**ADDENDUM  
NO. 3**

**October 11, 2024**

**Whiteland High School Ph 2: Café Kitchen Band Choir Auditorium**  
**300 E. Main Street**  
**Whiteland, IN 46184**

1 CHOIR 1 REHEARSAL ROOM AV DIAGRAM N.T.S.

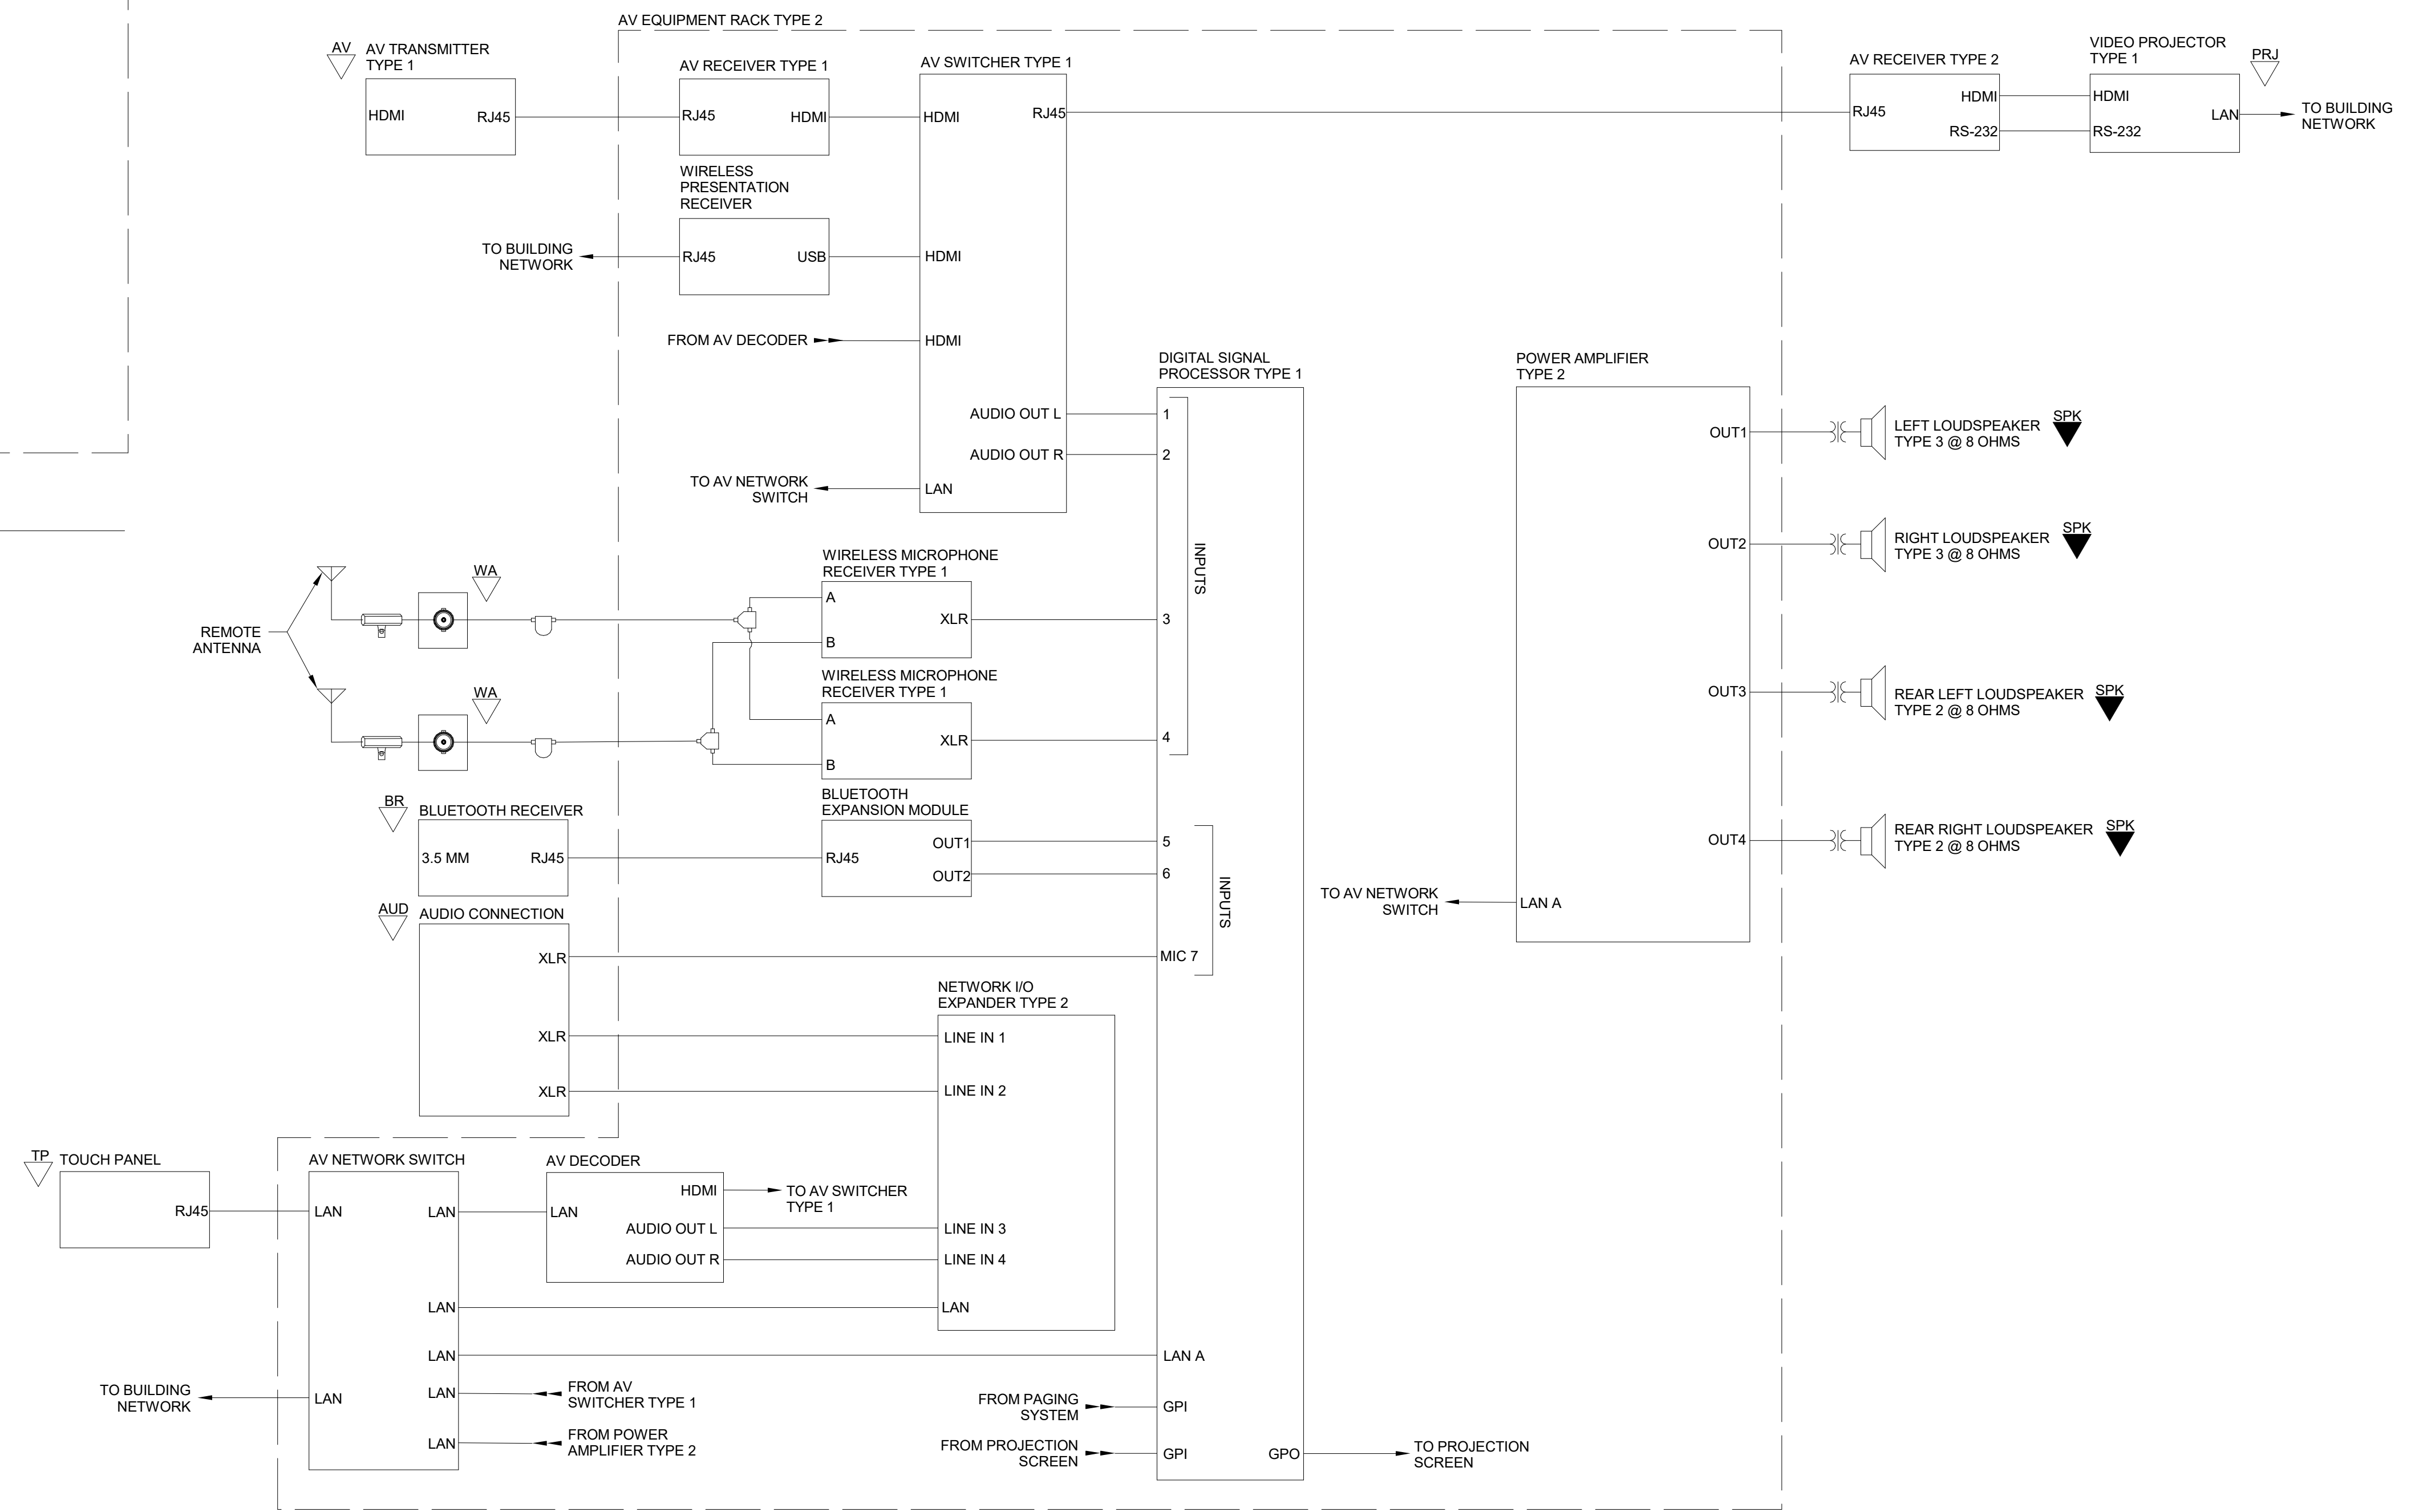
- a. Added additional loudspeaker installation instructions to Choir 1 Rehearsal Room AV Diagram

1 BAND REHEARSAL ROOM AV DIAGRAM  
N.T.S.

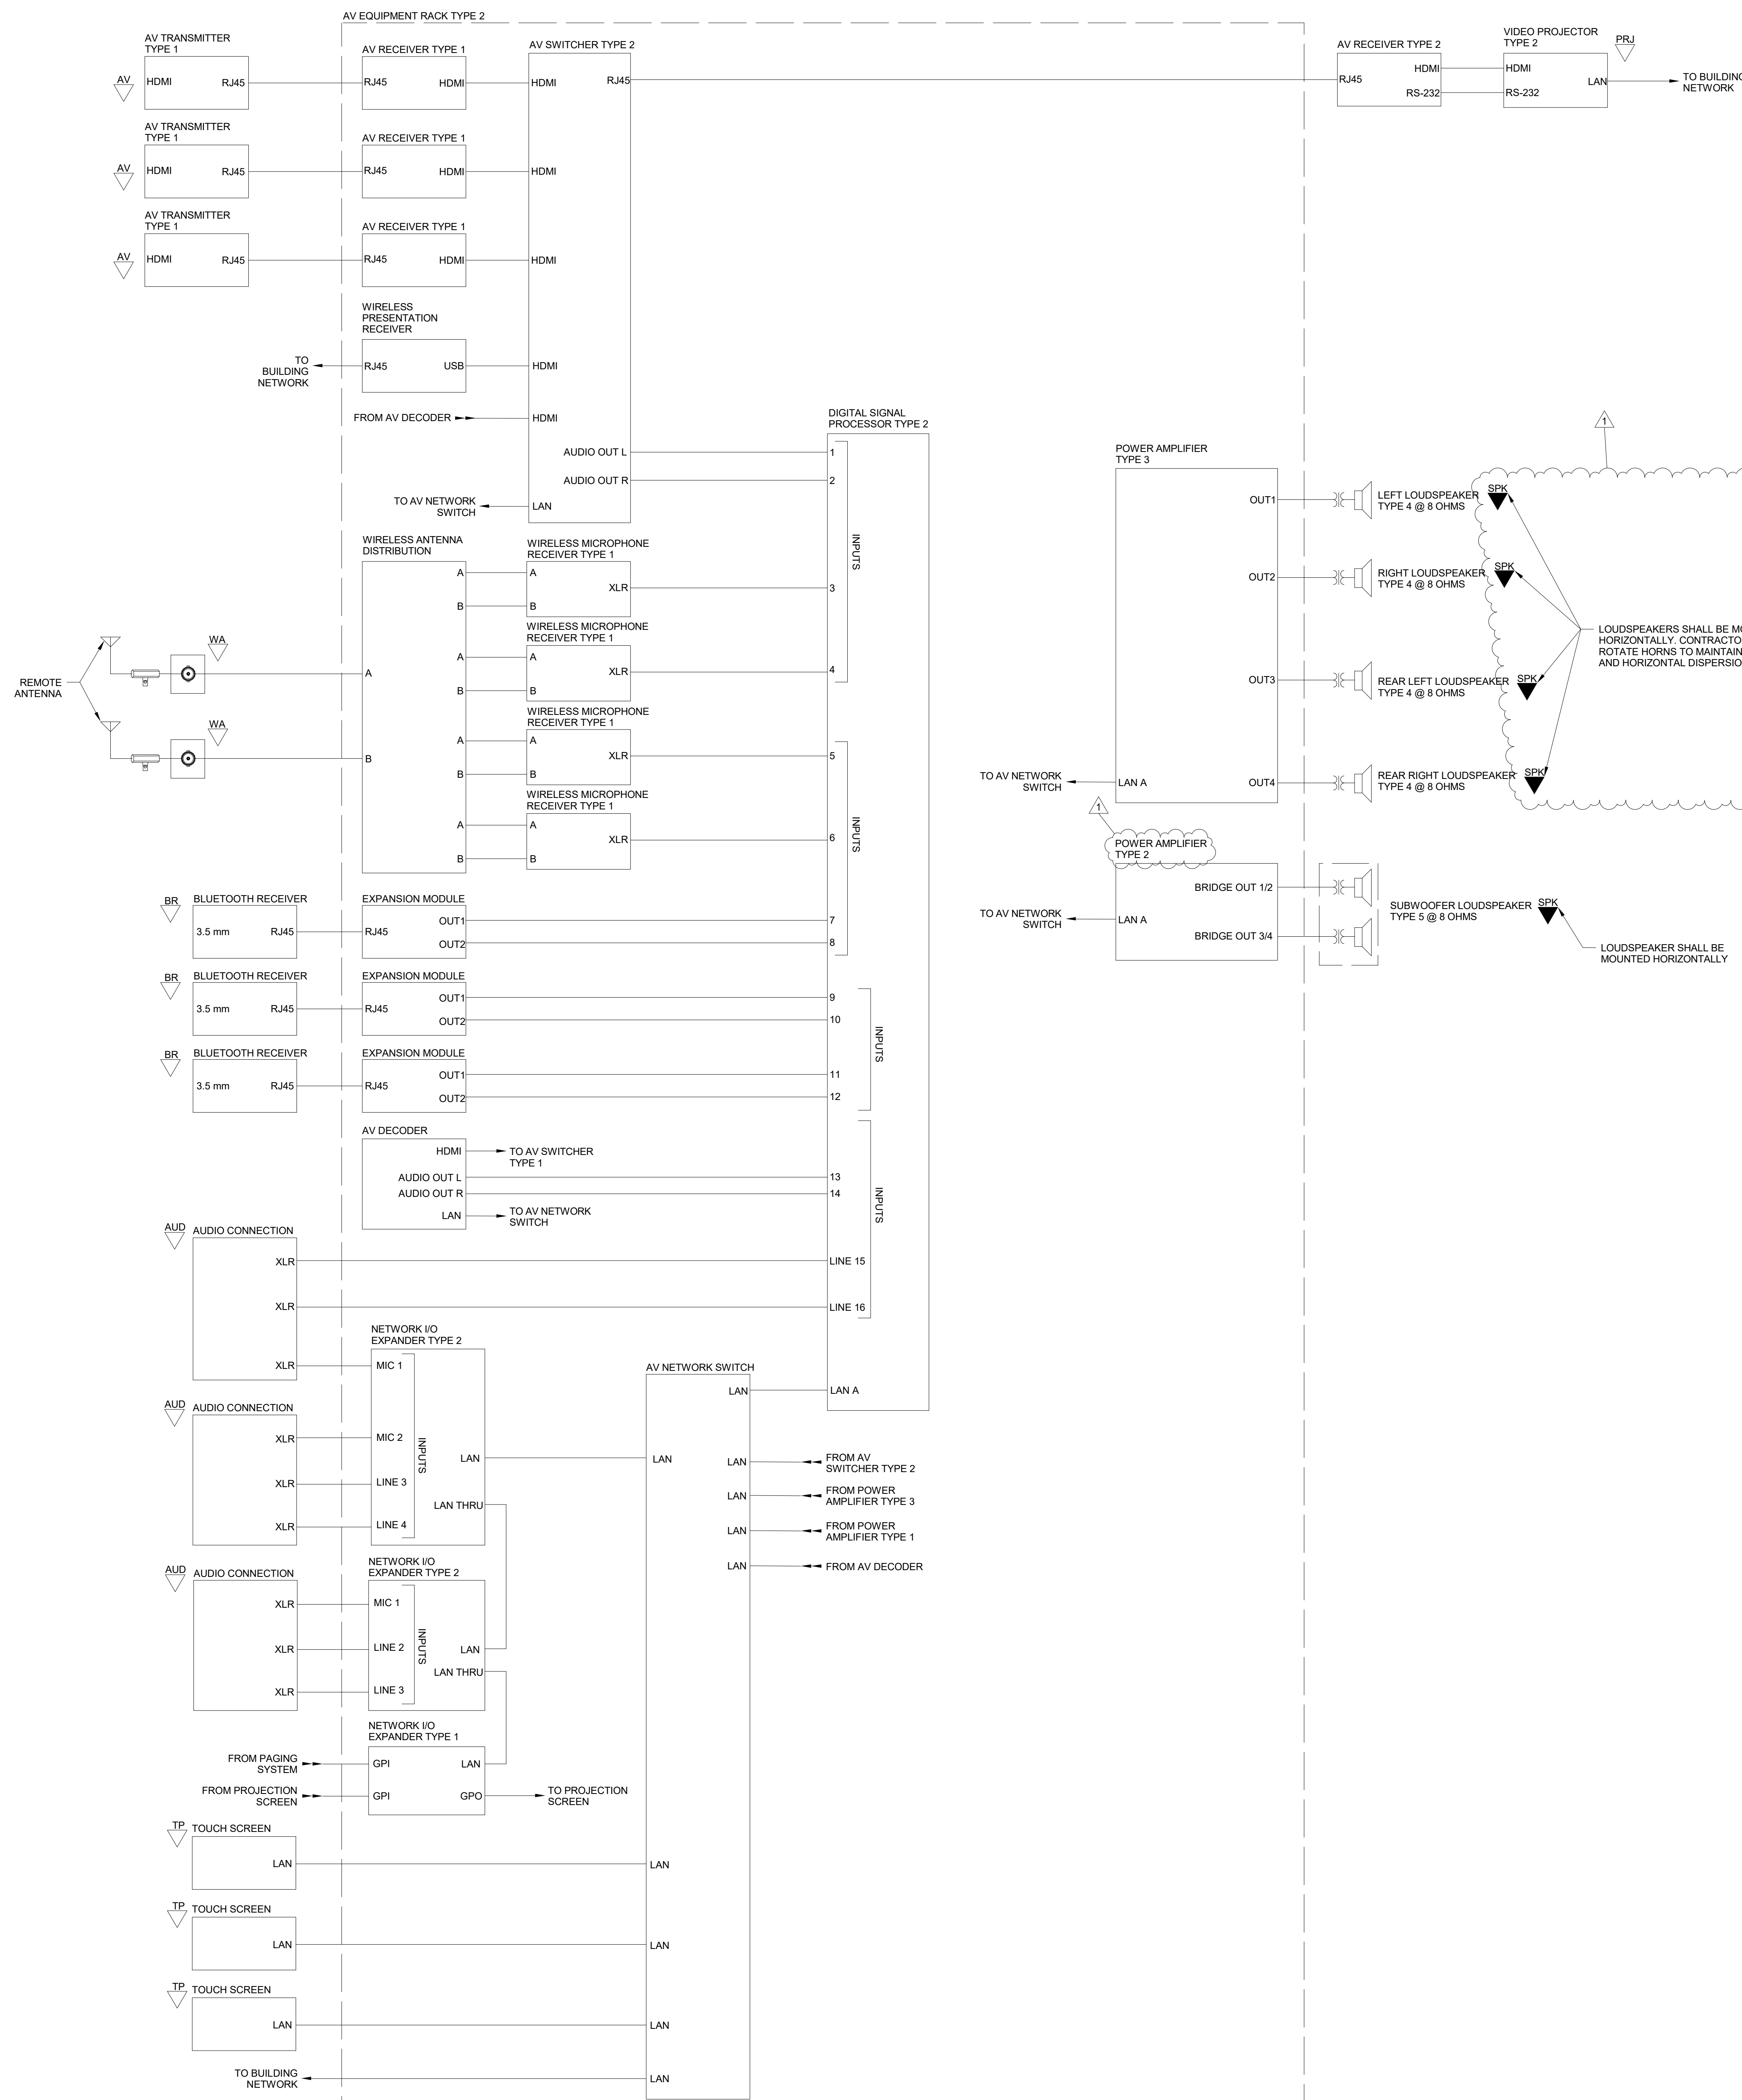
- a. Added additional loudspeaker installation instructions to Band Rehearsal Room AV Diagram
- b. Changed the power amplifier type feeding subwoofer loudspeaker type 5 to power amplifier type 2 in the Band Rehearsal Room AV Diagram

AUDITORIUM AUDIO SYSTEM AV  
 DIAGRAM - PART 1  
 1 N.T.S.

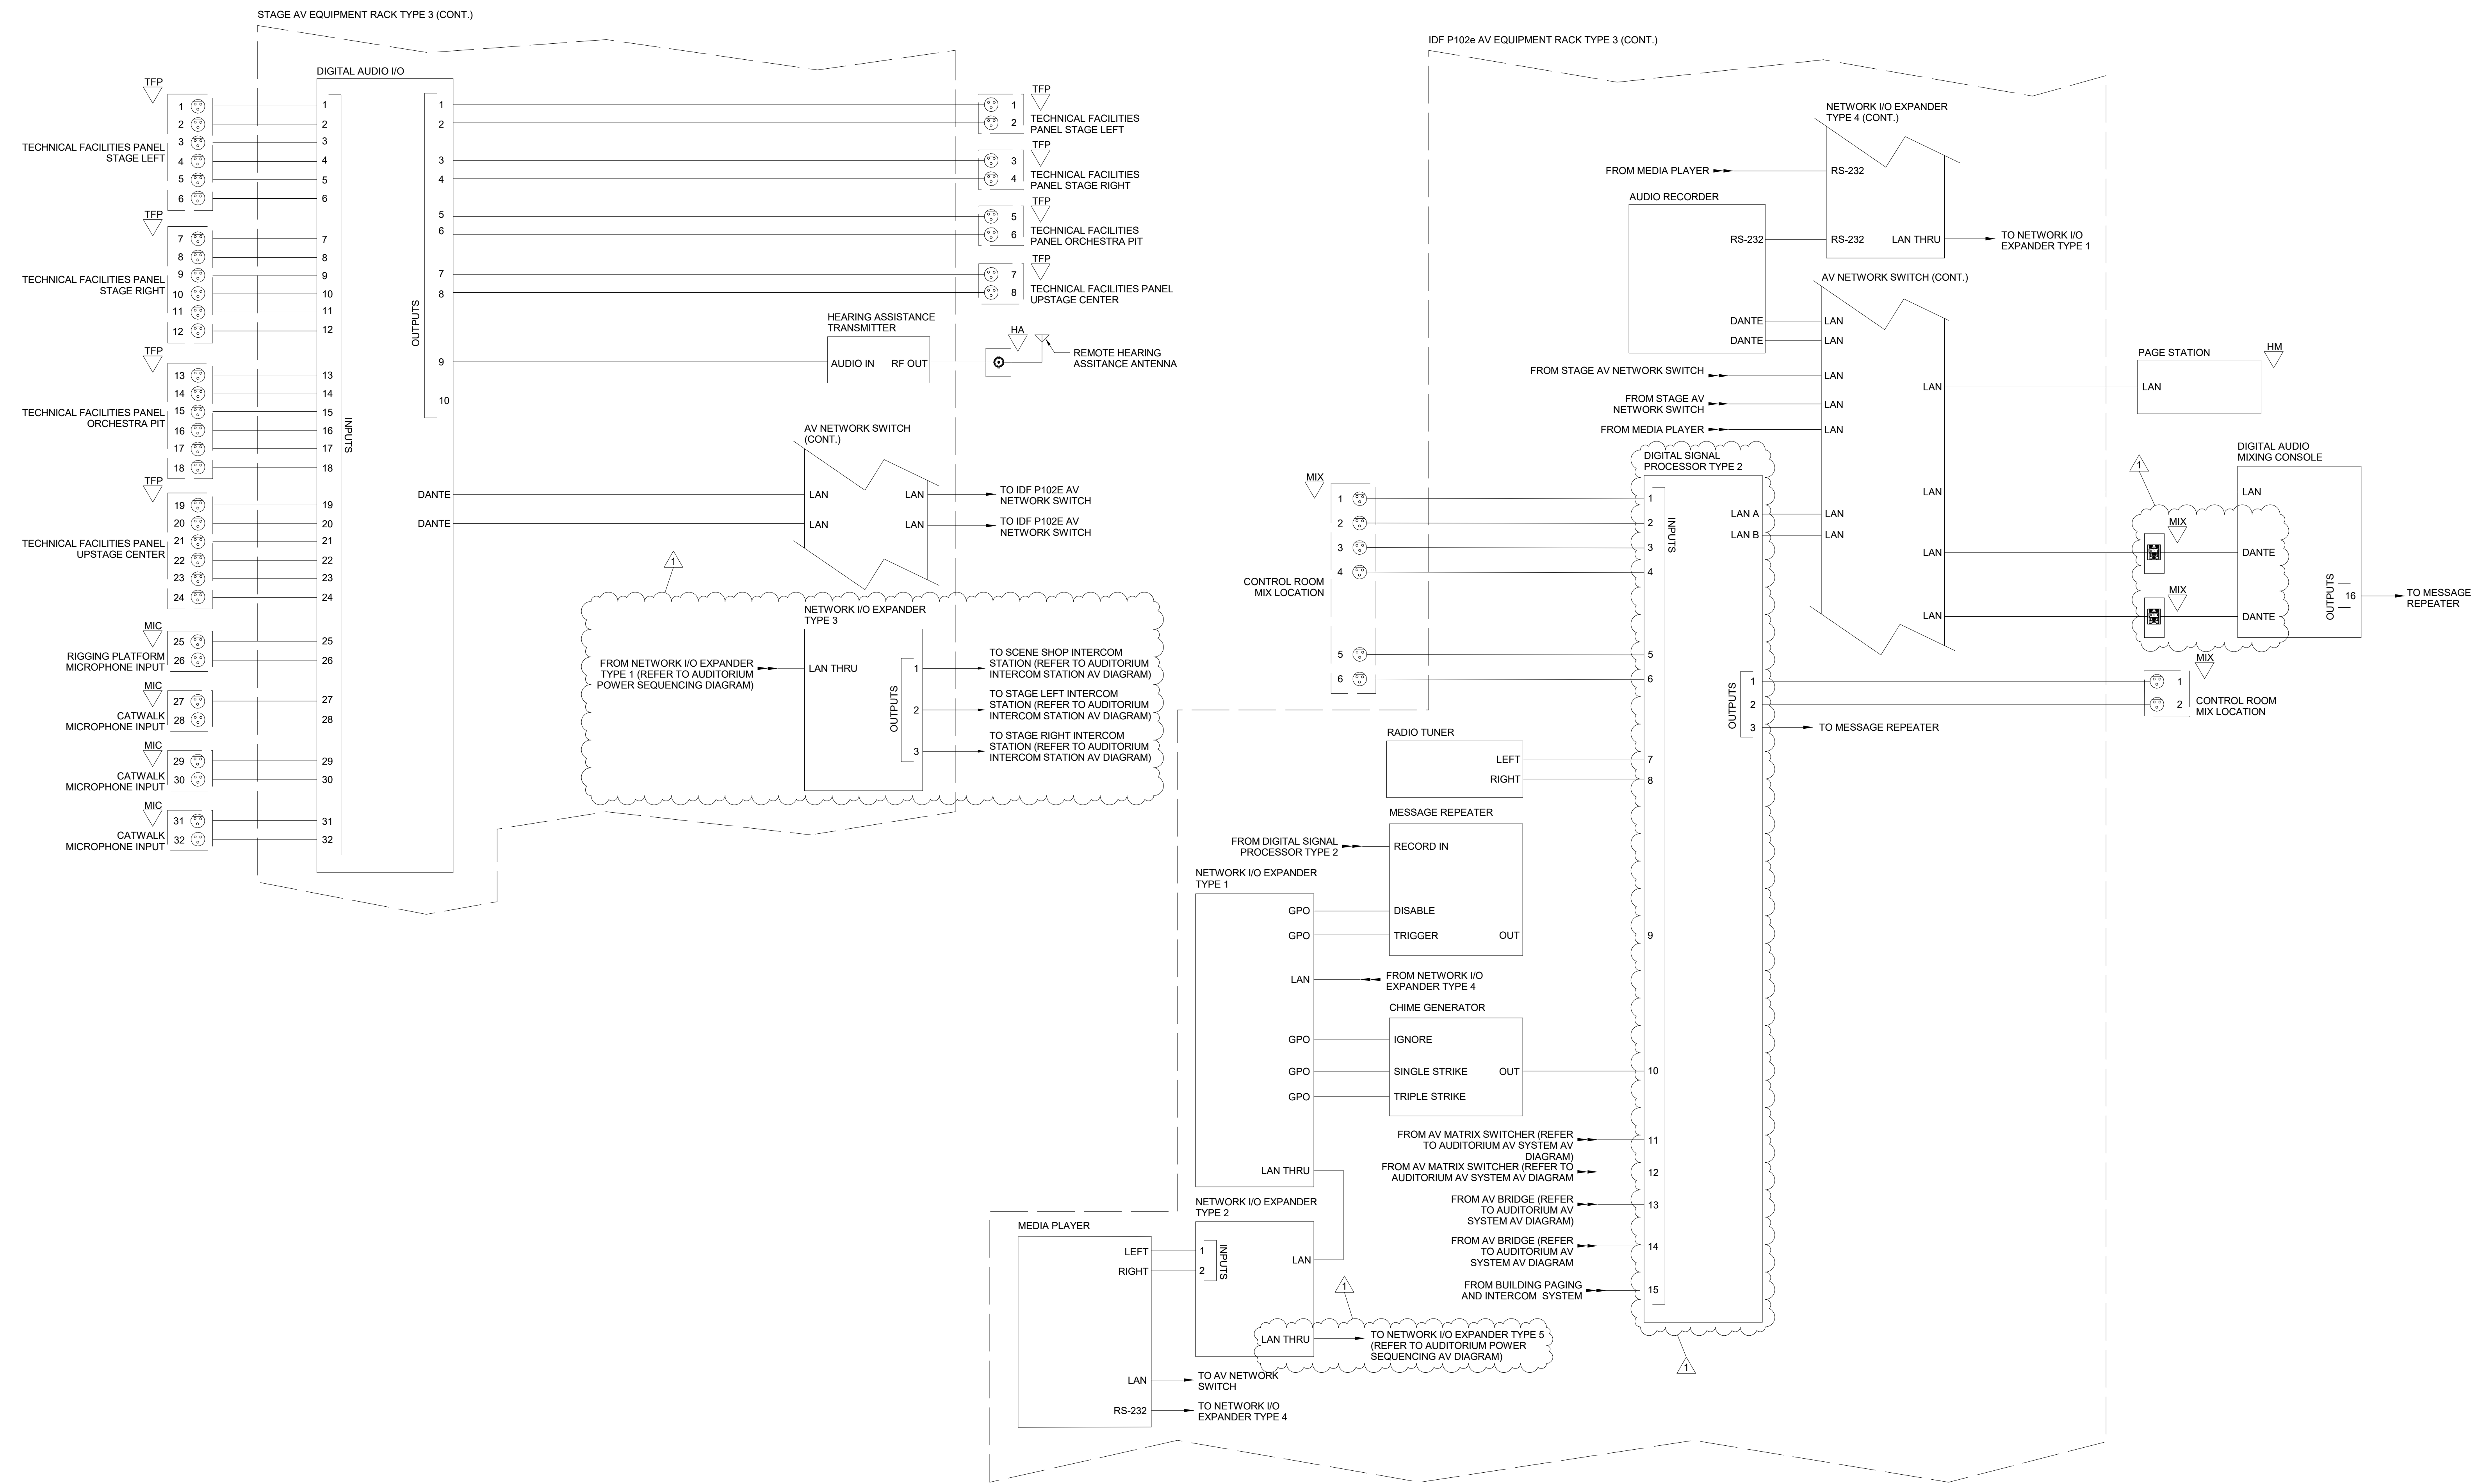
- a. Added new Network I/O Expander Type 3 feeding the program inputs of three intercom stations to the Auditorium Audio System AV Diagram – Part 1
- b. Moved the digital signal processor type 2 to the IDF P102e AV equipment rack and removed all network audio I/O expanders no longer required from the Auditorium Audio System AV Diagram – Part 1
- c. Updated Network I/O Expander Type 2 to include connectivity to Network I/O Expander Type 5 and references to the Auditorium Power Sequencing AV Diagram to the Auditorium Audio System AV Diagram – Part 1
